**ATEC**  
FRAMEWORK DEVELOPMENT PLAN  
AURORA, COLORADO

SITE ANALYSIS NARRATIVE

OPEN SPACE, CIRCULATION AND VILLAGE PLAN

**Sheet Title**  
OVERALL EXISTING  
FEATURES &  
NATURAL FEATURES MAP

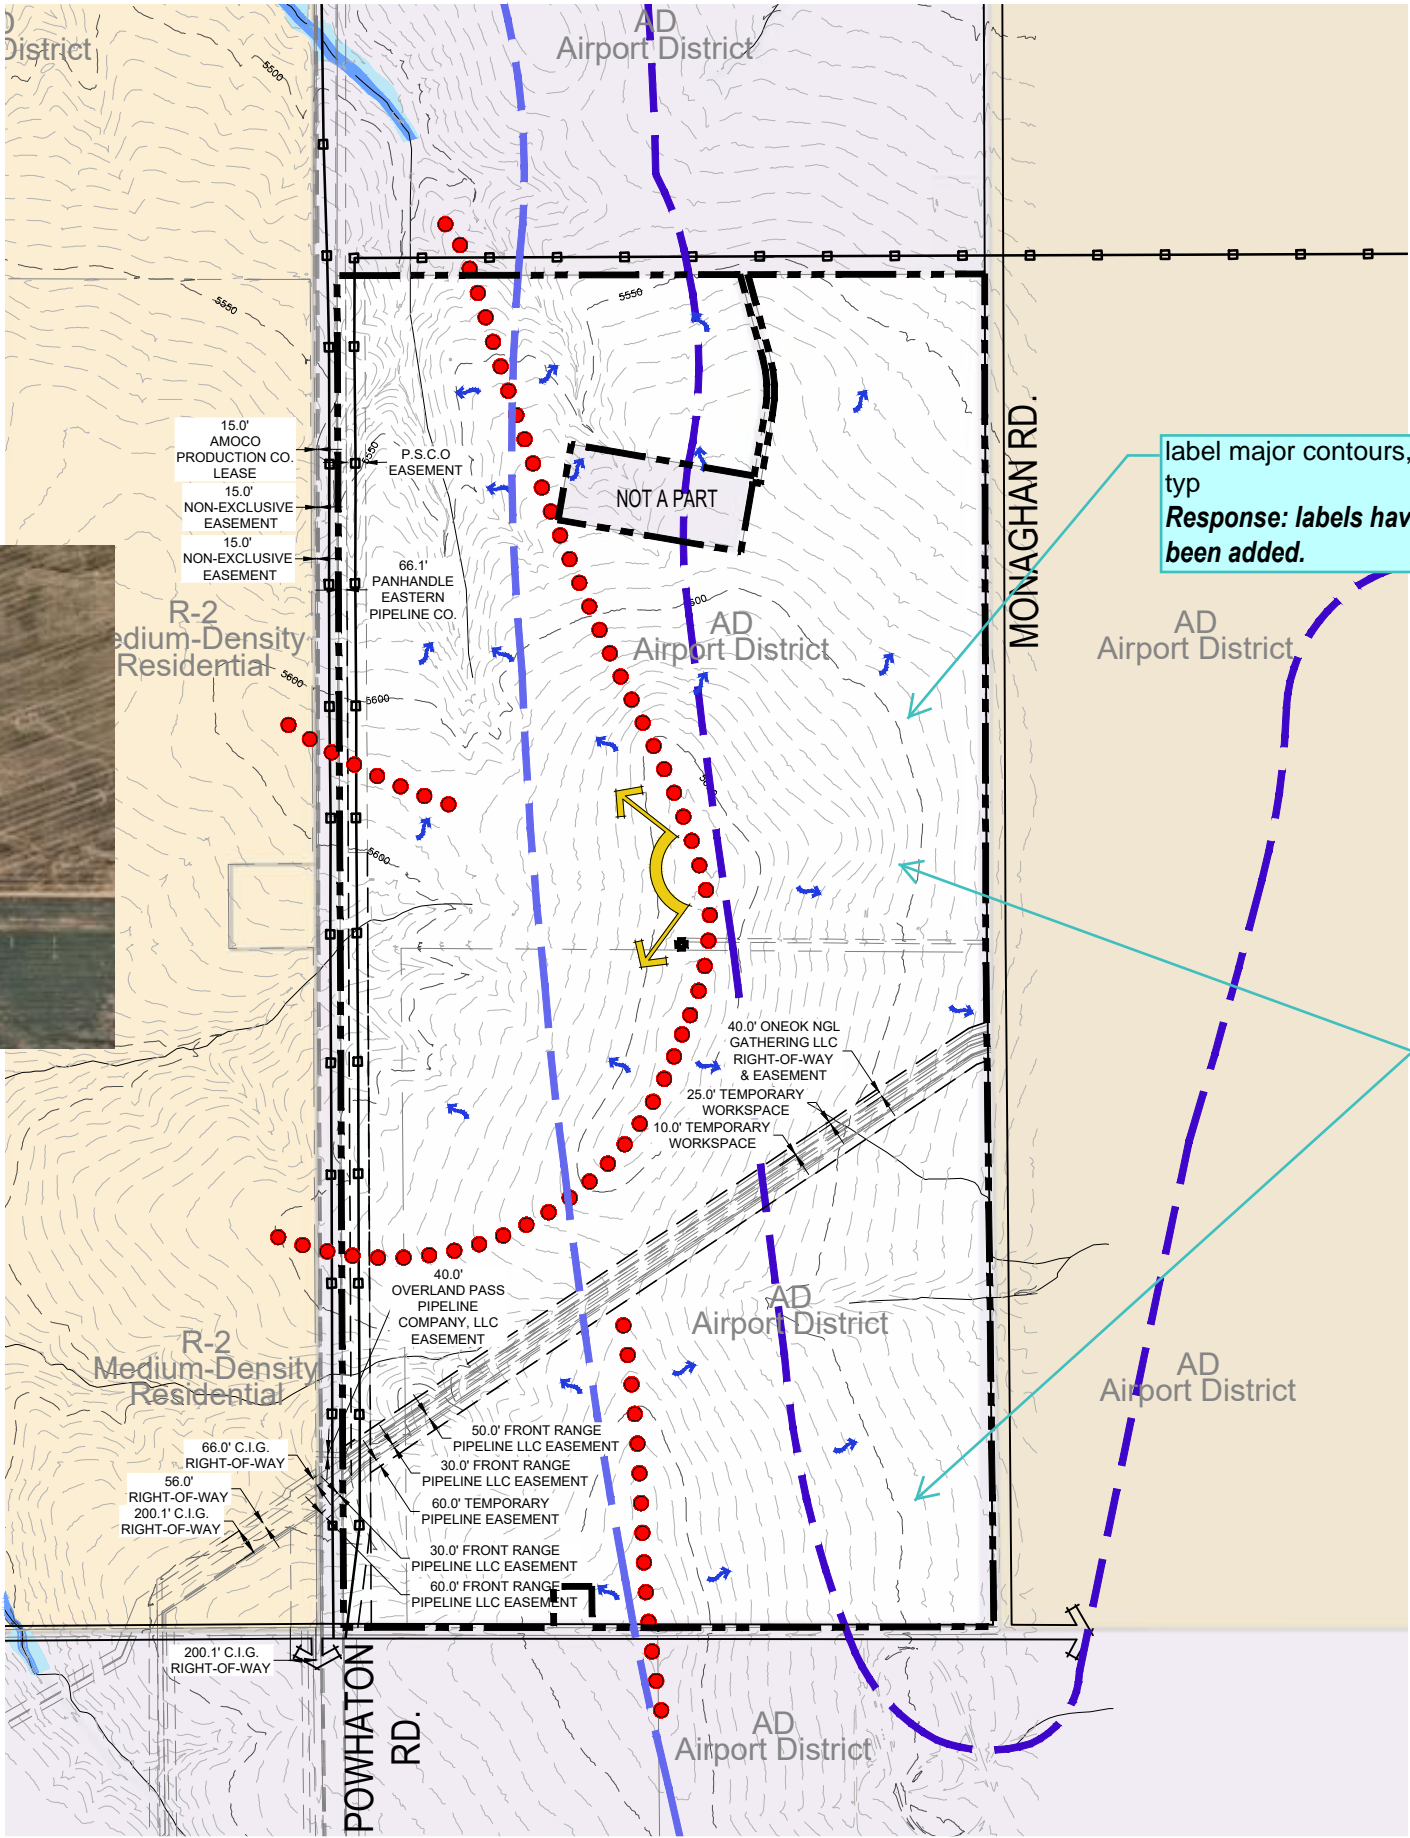
show existing buildings and oil and gas  
**Response: Existing buildings and oil and gas areas are now shown.**

label major contours, typ  
**Response: labels have been added.**

add noise contours  
**Response: Noise contours have been added.**

show existing on-site well pad sites  
**Response: Existing oil and gas located are shown.**

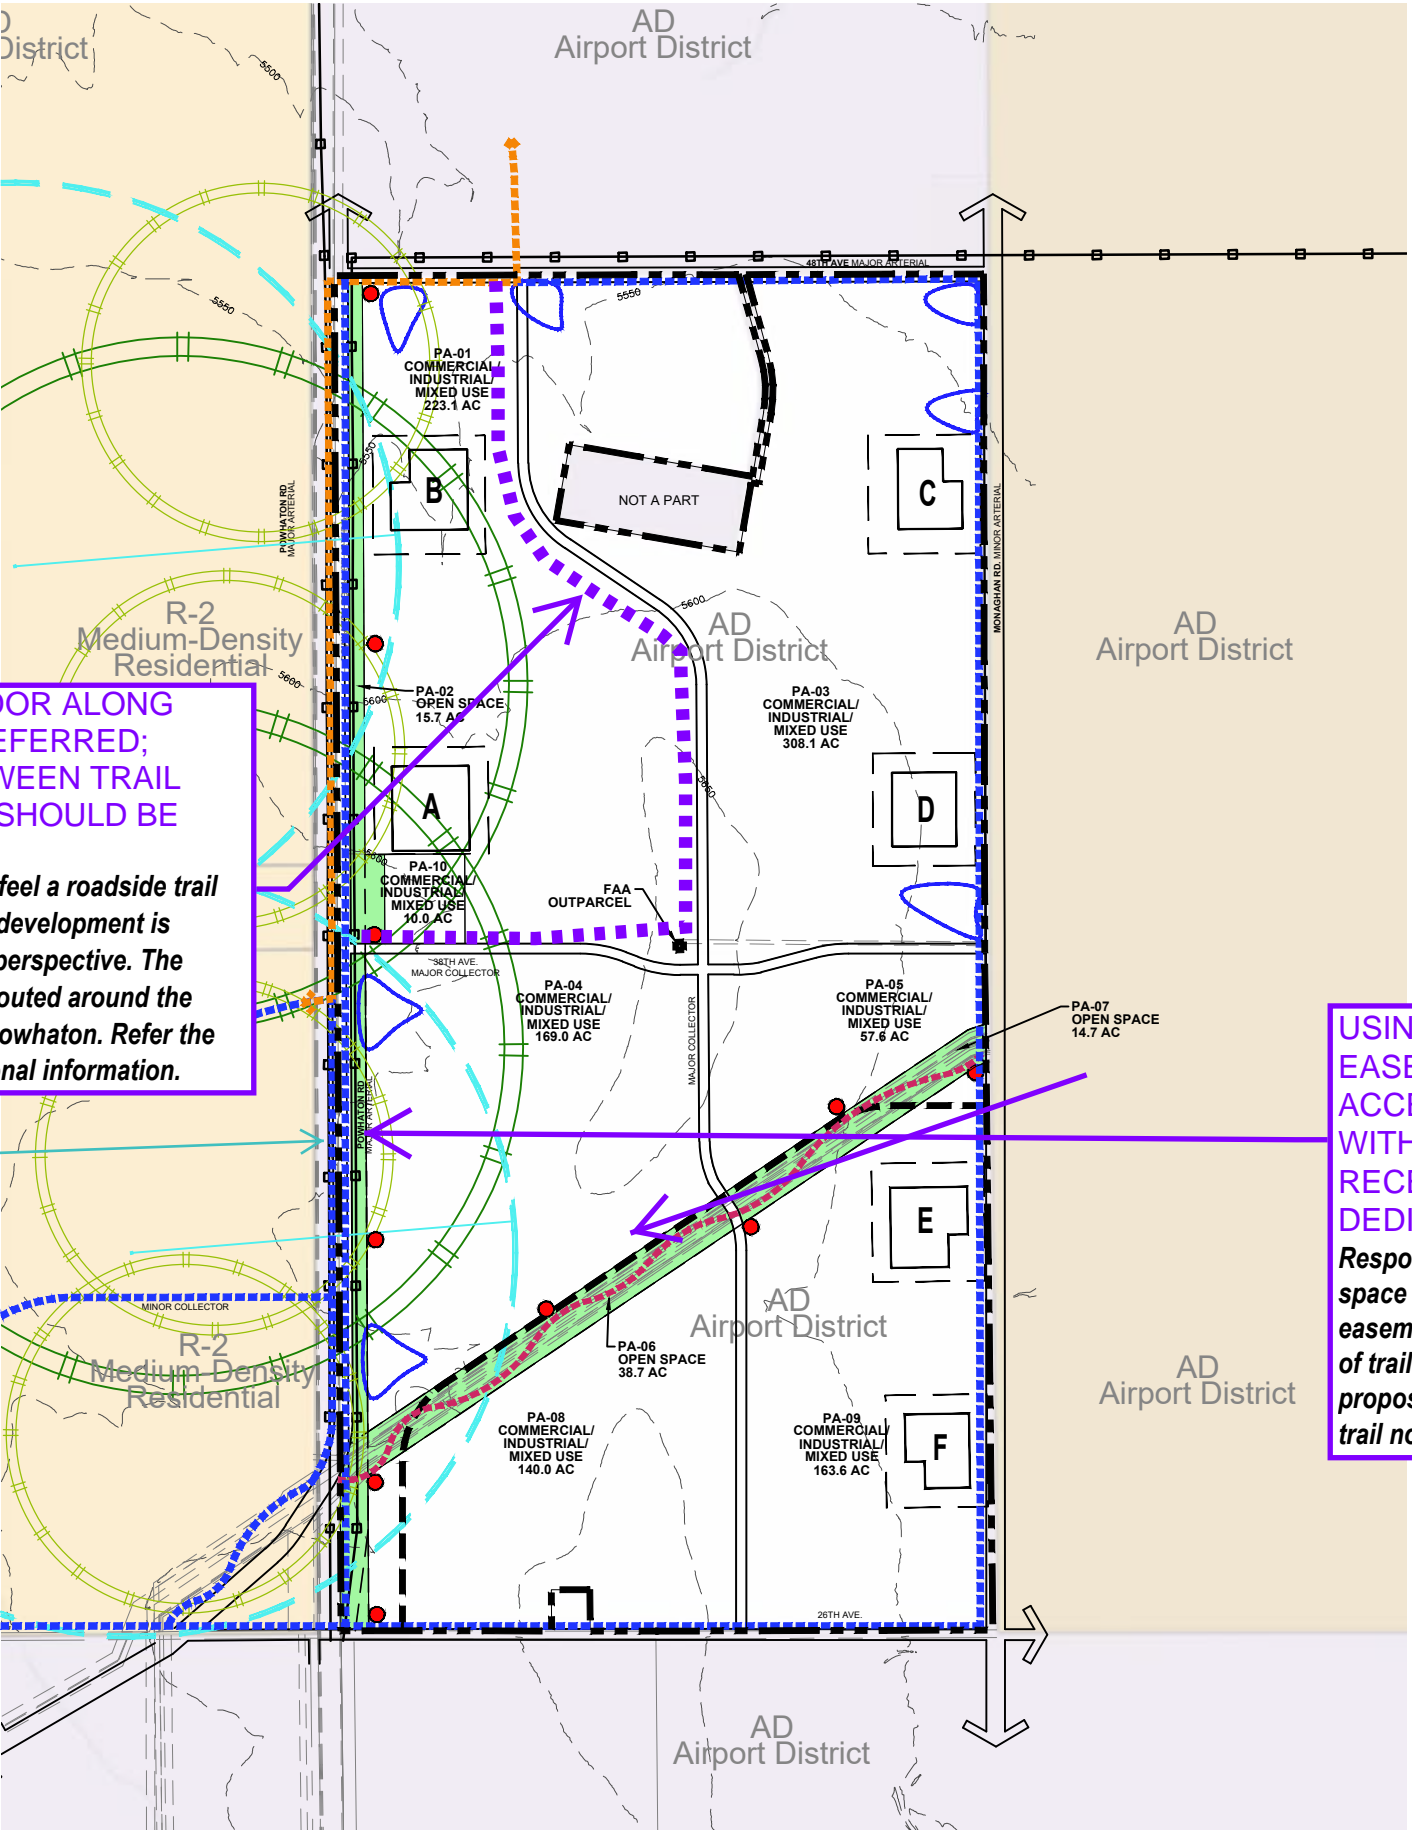
more info on location of Powhaton required. How will trail and pedestrian crossings be made  
**Response: Additional information regarding Powhaton Road has been provided in Tab 14.**

show TAH roads, trails, etc... and show coordination  
**Response: Additional context from The Aurora Highlands FDP has been added.**

internal road? criss-crosses trail?  
**Response: Roadway has been removed.**

in print this symbol is too similar to noise contours.  
**Response: Removed.**

add noise contours dashed green line  
**Response: Noise contours have been added to legend.**

add green dashed line to legend  
**Response: Trail line type has been added to the legend.**

coord. spacing from access from south of 26th Ave. (red mark)  
**Response: Road alignment has been revised to align with access to the south as indicated.**

TRAILS MASTER PLAN

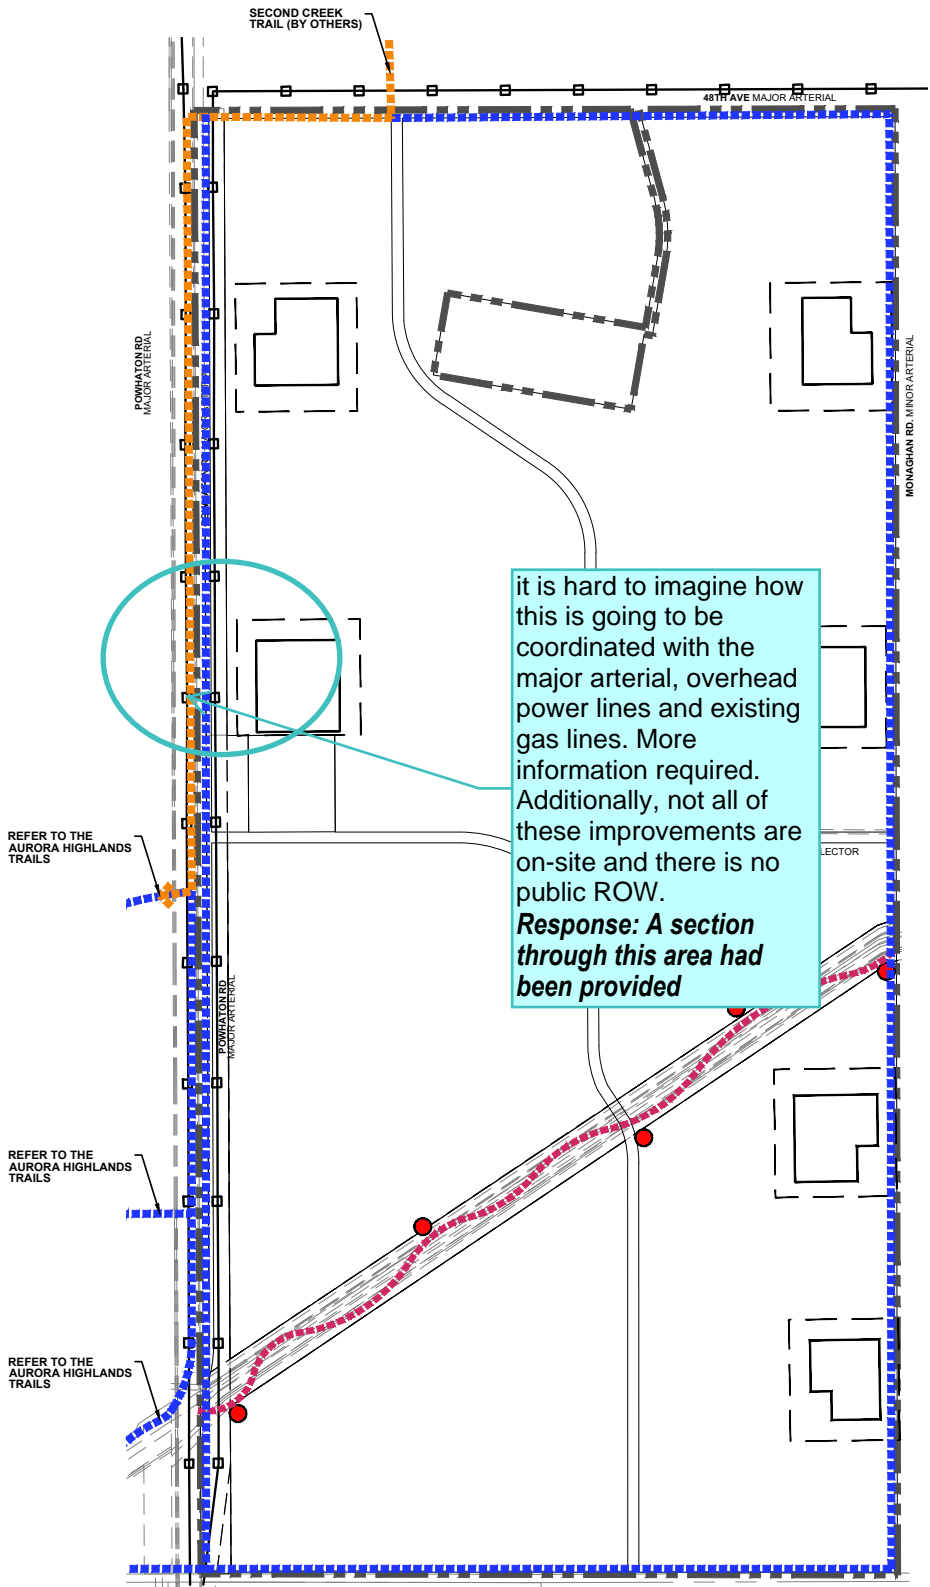
Change to PP  
RESPONSE: Revised.

SHEET  
OA  
1

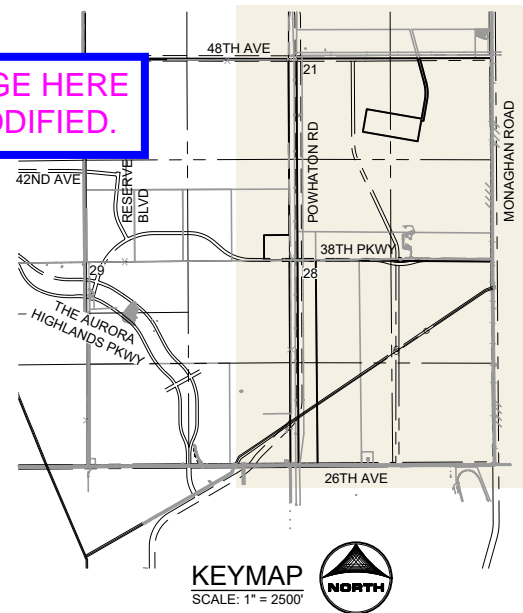
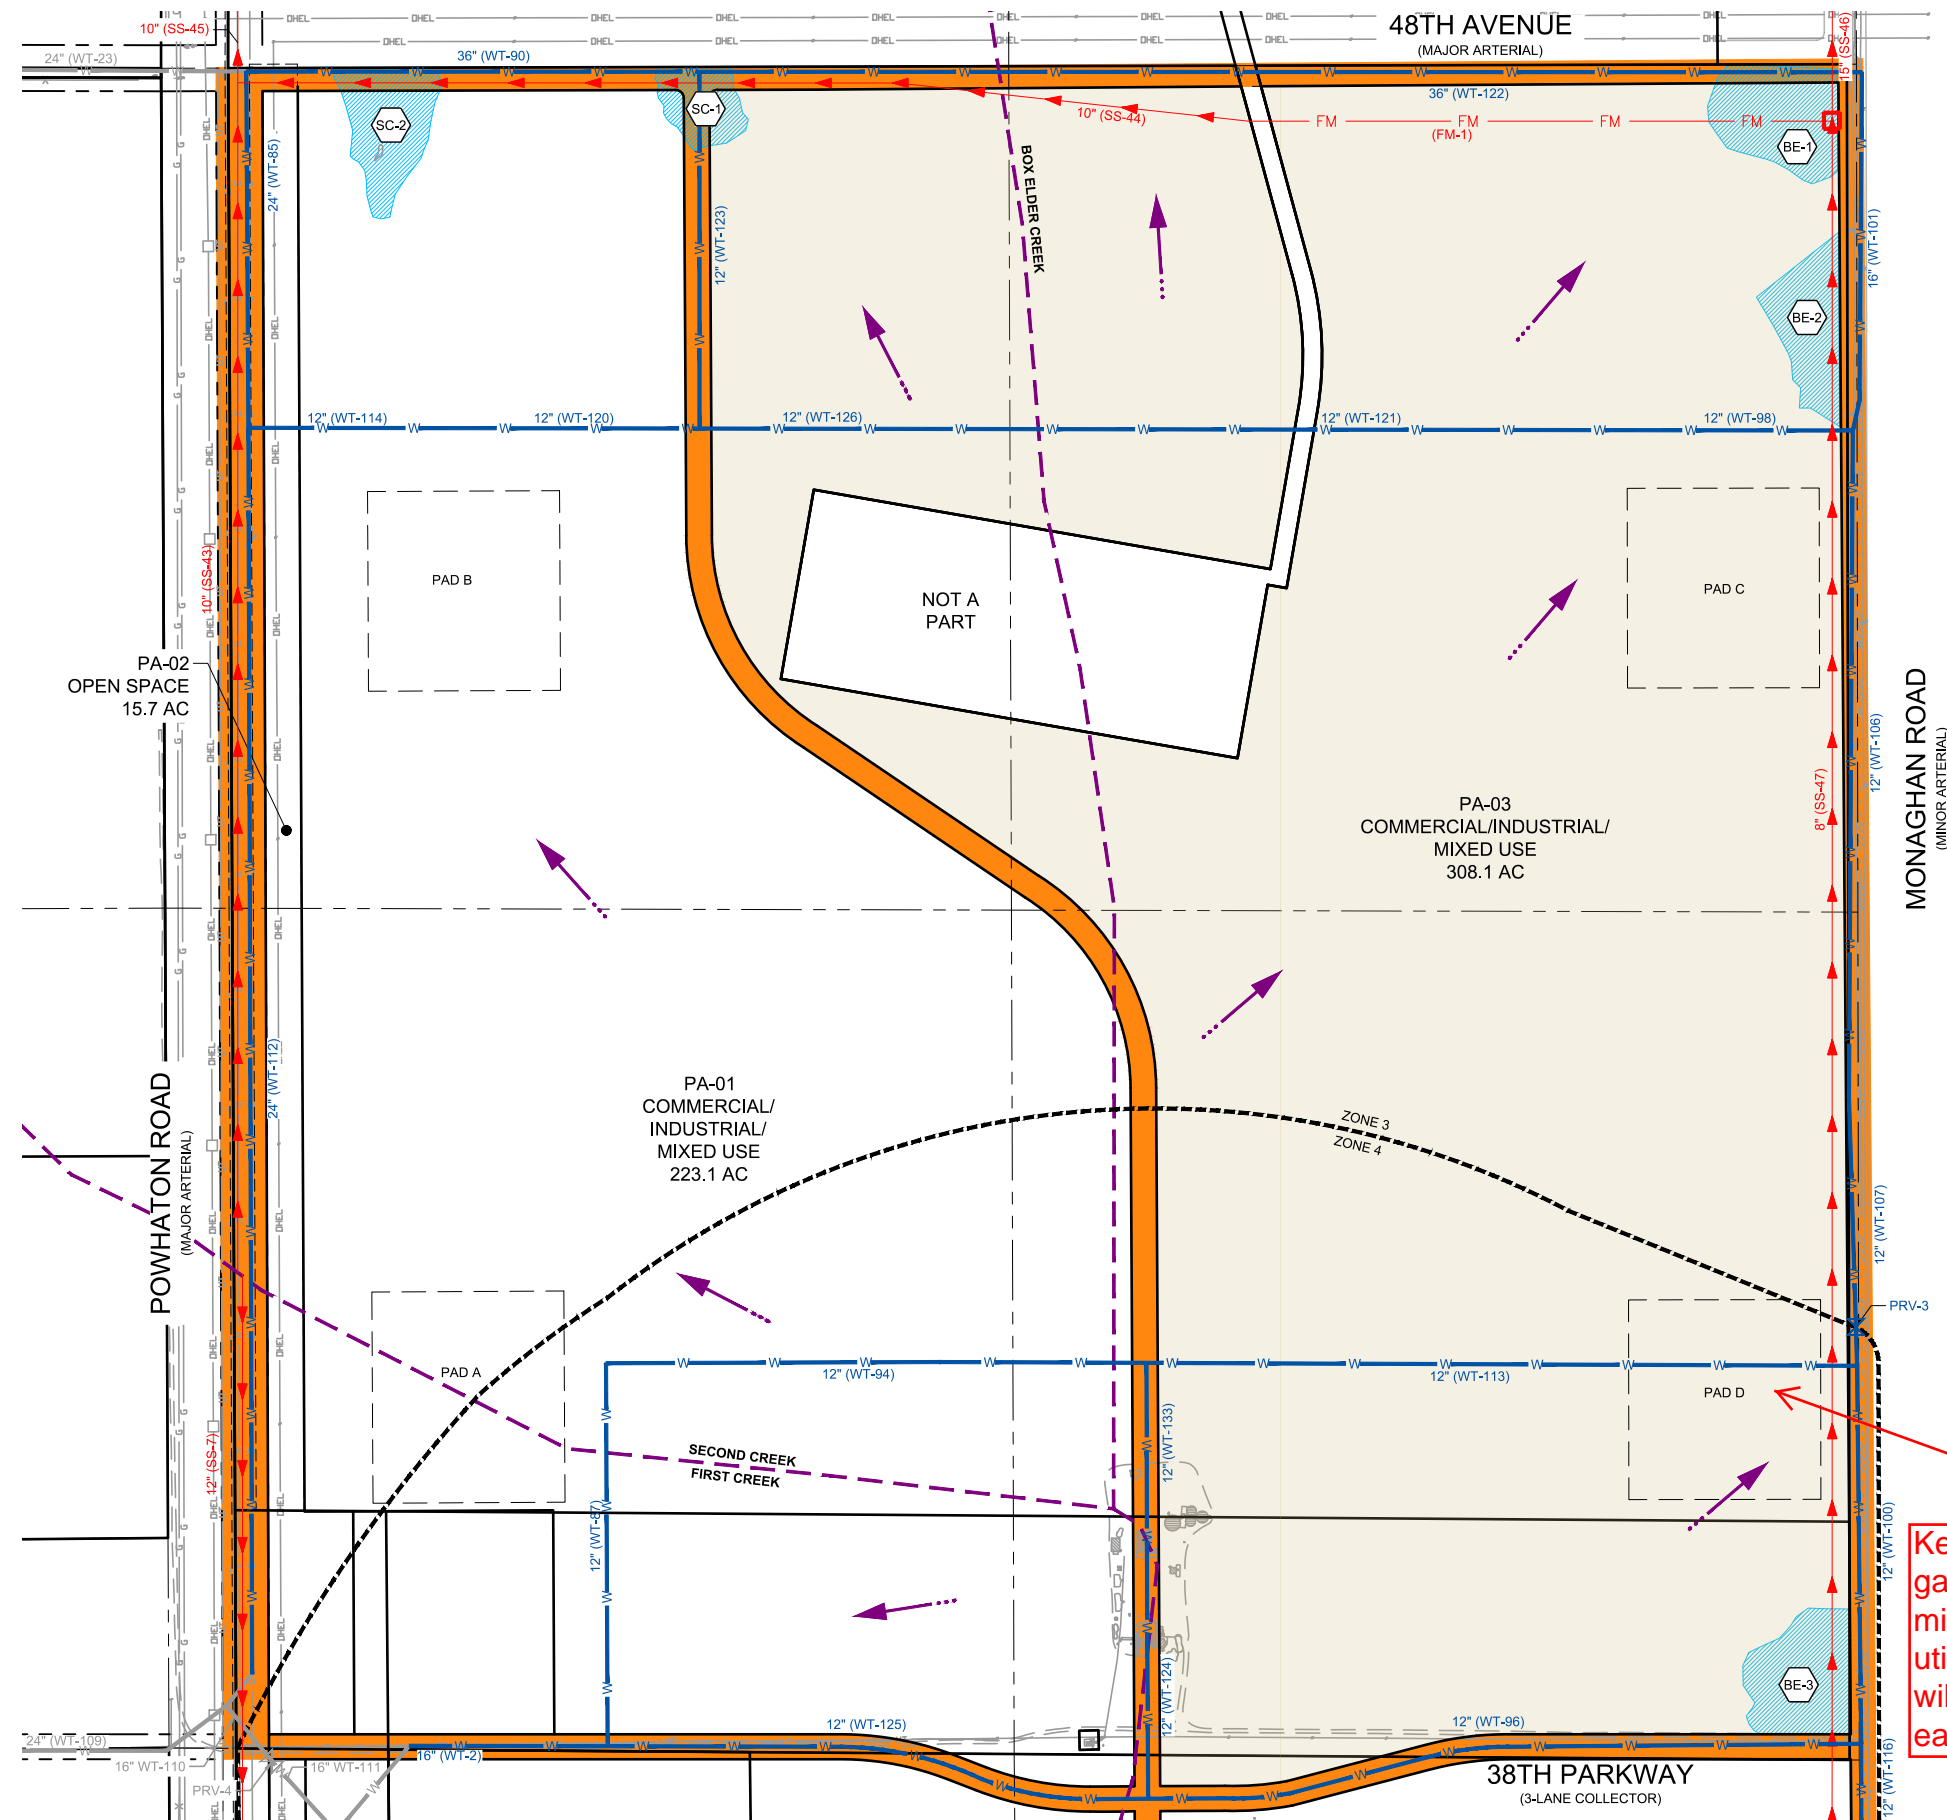
Will the creek be modified to avoid the pad site?

The Powhatan Road alignment needs to be consistent with TAH PIP. Improvement needs to be shown, but indicated to be done by TAH? Again addressing if PA-4 develops prior to TAH triggers for Powhatan

Please use language from typical sections or add street names to the typical sections

THE ALIGNMENT OF POWHATON ROAD IS CONSISTENT WITH THE APPROVED TAH PIP. LANGUAGE HAS BEEN ADDED TO REPORT FURTHER EXPLAINING PHASING.
